## Product Change Notice

PCN Ref Nº: PT10 V with improved (flanged) collector

New flange close up

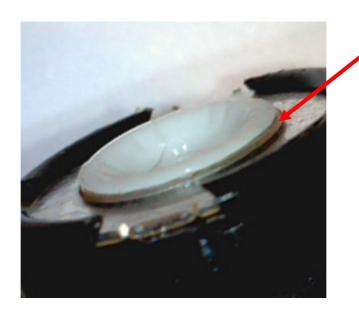
The collector for the PT10 V model has been redesigned to include a flange near the rotor's hole. This change affords significant improvements in terms of rotational feeling and improved torque & hysteresis.

**REASONS FOR CHANGE:** Improved rotational feeling. More homogeneous torque. Improved hysteresis.
